<b>AGENDA SECTION:</b> PUBLIC HEARINGS	<b>ORIGINATING DEPT:</b> PLANNING	<b>ITEM NO.</b> <i>E-4</i>
<b>ITEM DESCRIPTION:</b> Land Subdivision Permit (Preliminary Plat) #03-14 to be known as Valley Side Estates Third by Freedom Development & Consulting LLC. The Applicant is proposing to subdivide approximately 33.41 acres of land into 59 lots for single-family development and 2 Outlots. The Plat also proposes to dedicate new public roadways. The property is located east of Valley Estate Second Subdivision and south of Highway 14 East.		<b>PREPARED BY:</b> Brent Svenby, Planner

**RE: Land Subdivision Permit (Preliminary Plat) #03-14 to be known as Valley Side Estates Third by Freedom Development & Consulting LLC. The Applicant is proposing to subdivide approximately 33.41 acres of land into 84 lots for single family development and 3 Outlots. The Plat also proposes to dedicate new public roadways. The property is located east of Valley Estate Second Subdivision and south of Highway 14 East**

### PRELIMINARY PLAT #03-14

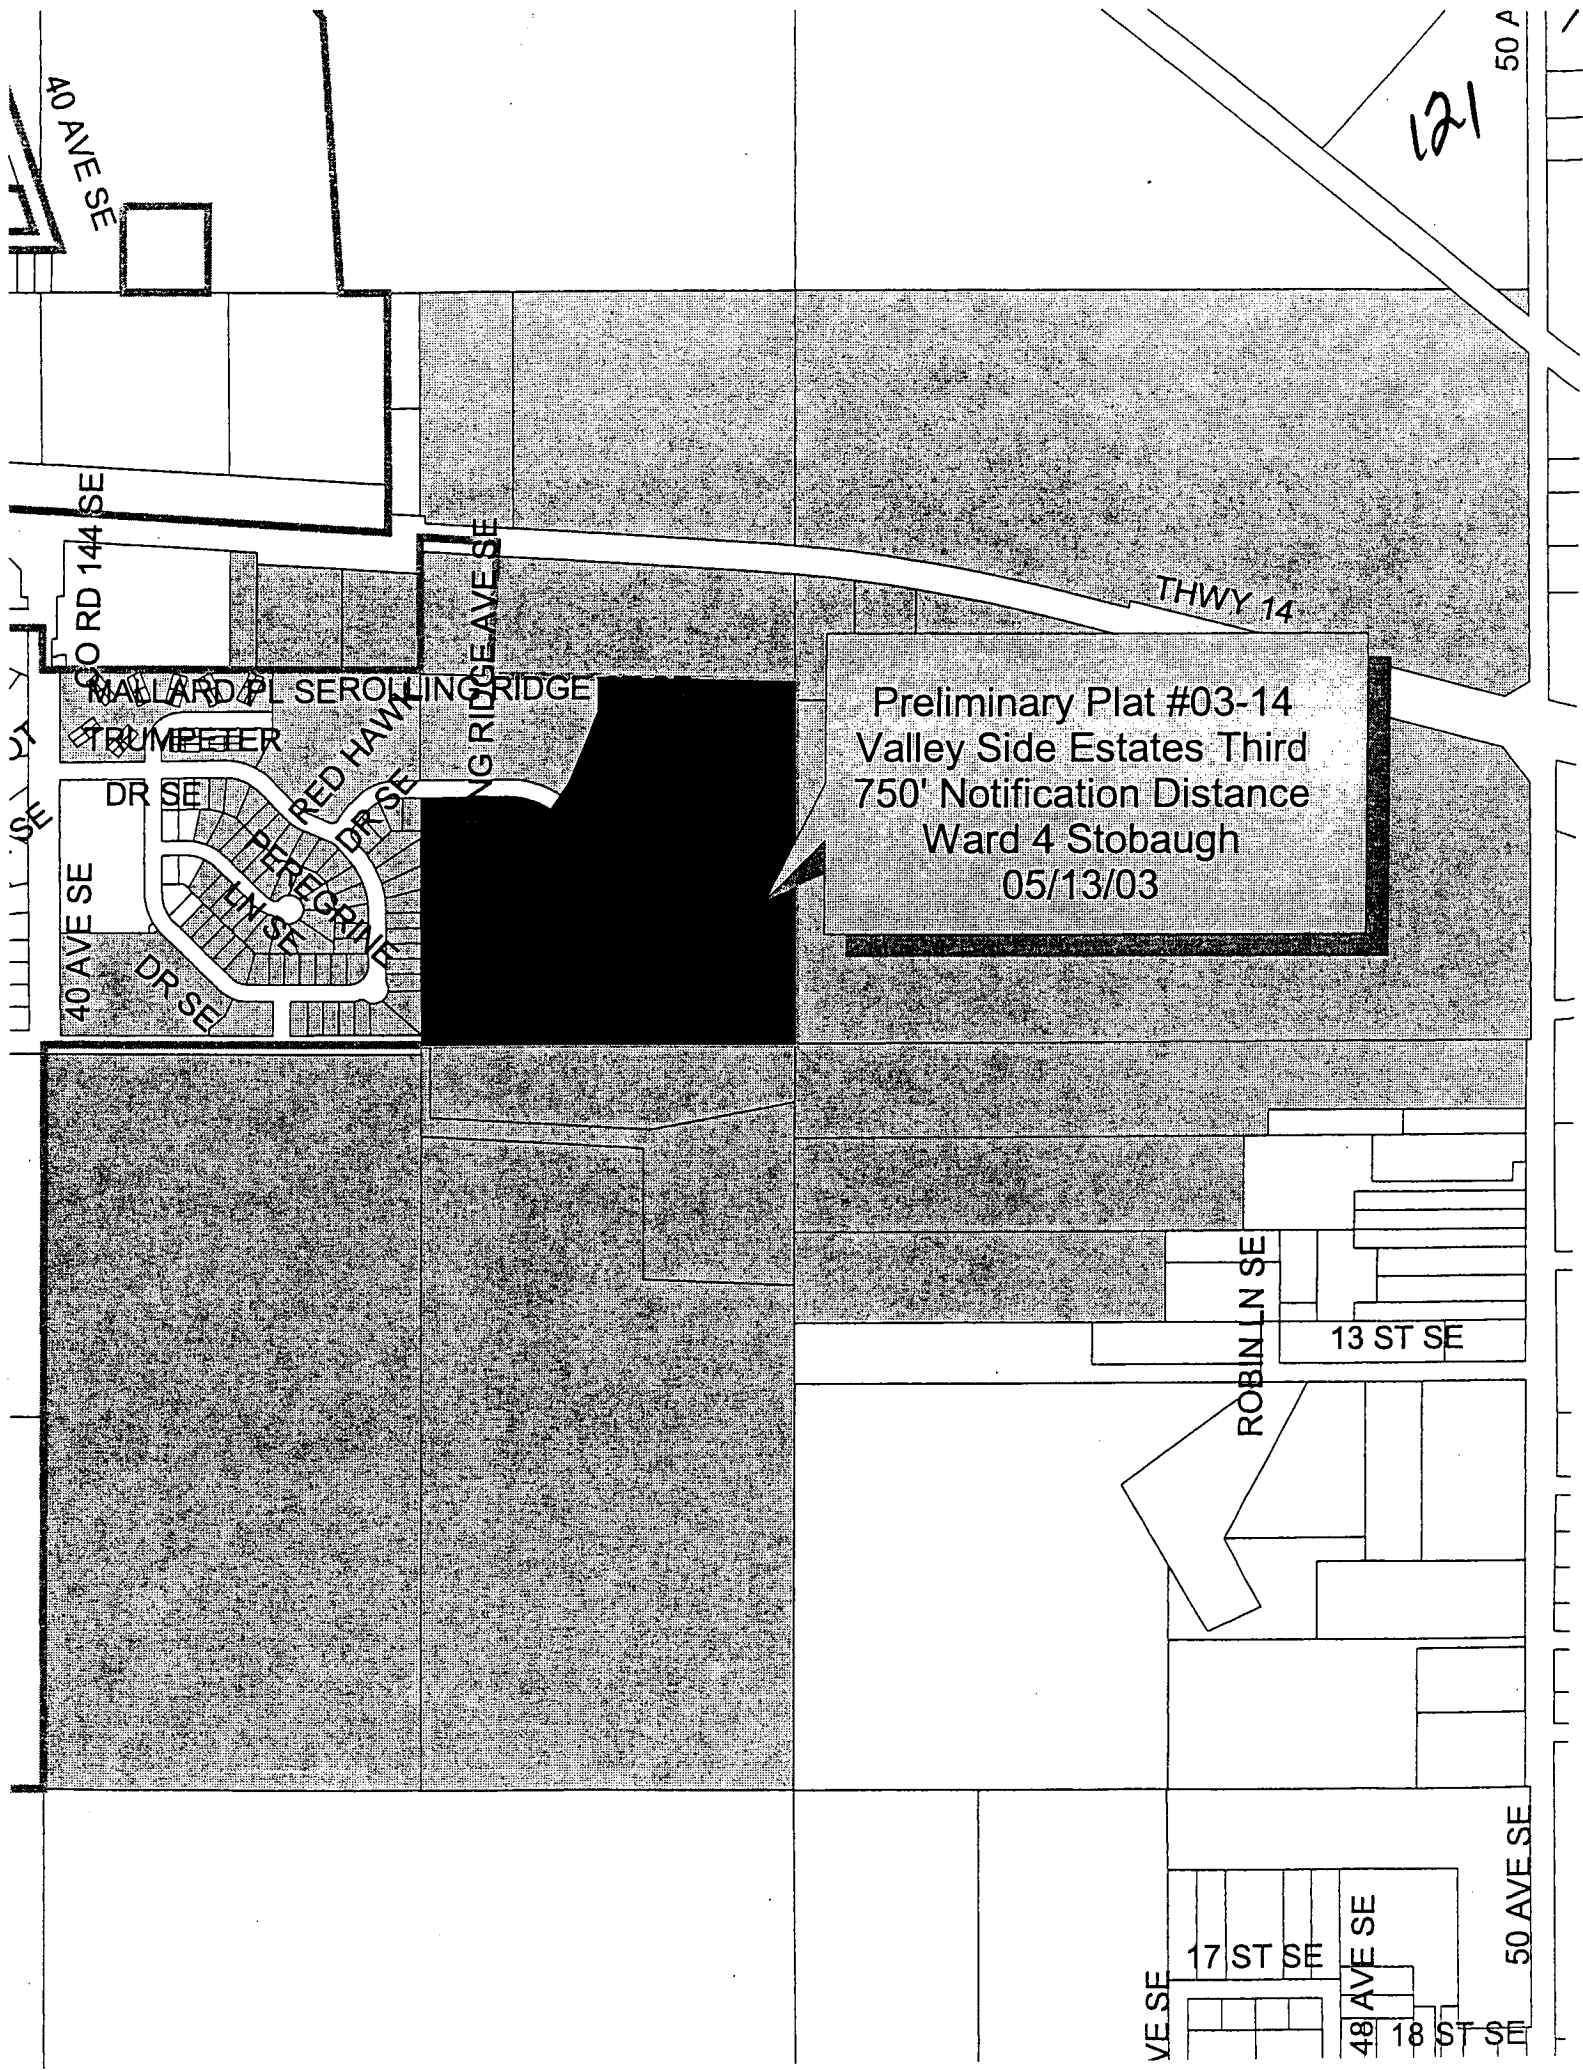
**NOTE:** The applicant submitted a revised plat addressing recommended conditions number 1 and 9 so those conditions can be removed.

Utilities will be extended from the west to accommodate this development. Additional 20' minimum public utility easements are required between Lots 20 & 21, Block 1 and Lots 8 & 9, Block 3 for the required water main loops to serve adjacent parcels and to provide adequate networking of the water system. Public utility easements will be required in Outlots B & C for the required water main loops connecting the cul-de-sacs and the existing stub-out from Valley Side Estates Second to the west. These easements can be dedicated as a part of the development of the outlots depending on where the actual phase limits are. Static pressure within the area will range from 68 to 79 PSI.

1. RED HAWK DRIVE SE needs to be illustrated east of intersection with Falcon Place SE.

2. FALCON PLACE SE is too long a roadway to be designated as a Place.

3. FALCON COURT SE is using an incorrect roadway type for a cul-de-sac roadway.

4. STARLING COURT SE is using an incorrect roadway type for a cul-de-sac roadway.

5. WHITE OWL COURT SE is using an incorrect roadway type for a cul-de-sac roadway.

**RECOMMENDATION:** Duplicate text for **RED HAWK DRIVE SE** to short stretch of roadway lying east of intersection with Falcon Place SE.

**RECOMMENDATION:** Change Falcon Place SE, both north and south of Red Hawk Drive SE to **FALCON ROAD SE**.

**RECOMMENDATION:** Change Falcon Court SE to **FALCON LANE SE**.

**RECOMMENDATION:** Change Starling Court SE to **STARLING LANE SE**.

**RECOMMENDATION:** Change White Owl Court SE to **WHITE OWL LANE SE**.
